SUBJECT: Lee County, Sanford Bypass; Federal Aid Project BRNHS-  
32(13); WBS 38461.1.1; **TIP R-2417AA**

Subject: Action ID No. SAW 2008-20899, TIP No. R-2417AA, US 421-NC 87 Sanford Bypass, Lee County, North Carolina.

Subject: Modification to the 401 Water Quality Certification Pursuant to Section 401 of the Federal Clean Water Act with ADDITIONAL CONDITIONS for Proposed improvements to US 421-NC 87 (Sanford Bypass) from West of SR 1400 to West of US-1/15/501 in Lee County. Federal Aid Project No. STPNHF-421(2)), State Project 8.T540402, WBS Element No. 34431.1.1 TIP Project No. R-2417AA. NCDWQ Project No. 00-1432 v.9

# Site # 5

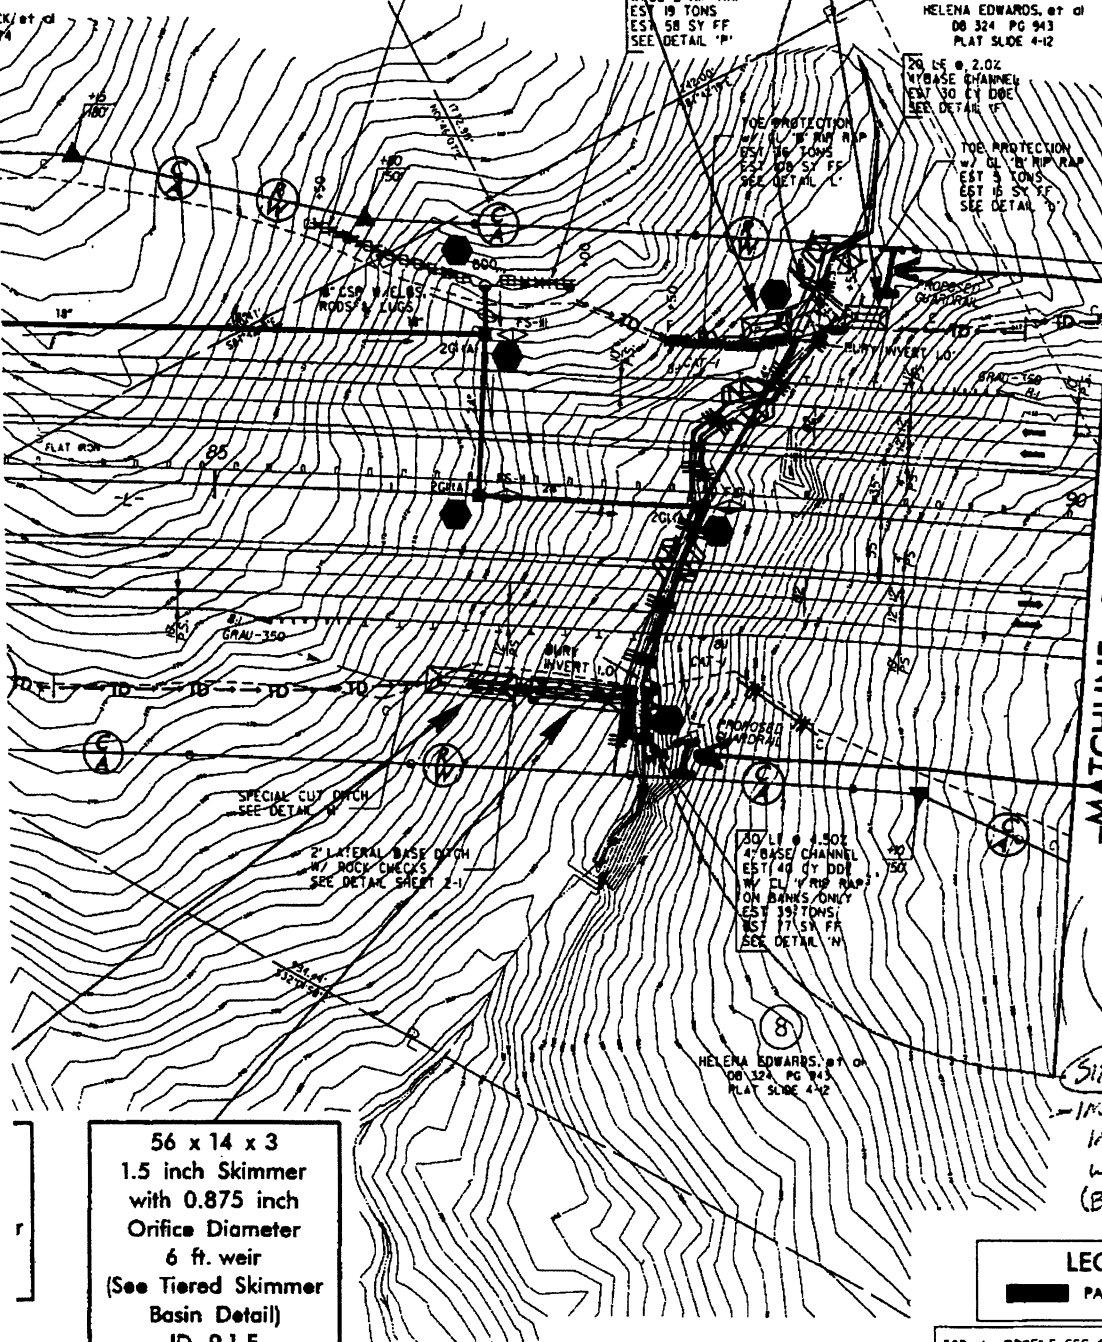
At Permit Site 5, NCDOT will design and install a series of rock veins on the outlet end of the 54" RCP to create a natural stream profile and enhance aquatic organism passage. NCDOT will coordinate these efforts with the Division of Water Quality and provide "as-built" drawings when completed.

3. At Permit Site 5, NCDOT will design and install a series of rock veins on the outlet end of the 54" RCP to create a natural stream profile and enhance aquatic organism passage. NCDOT will coordinate these efforts with the Division of Water Quality and provide "as-built" drawings when completed.
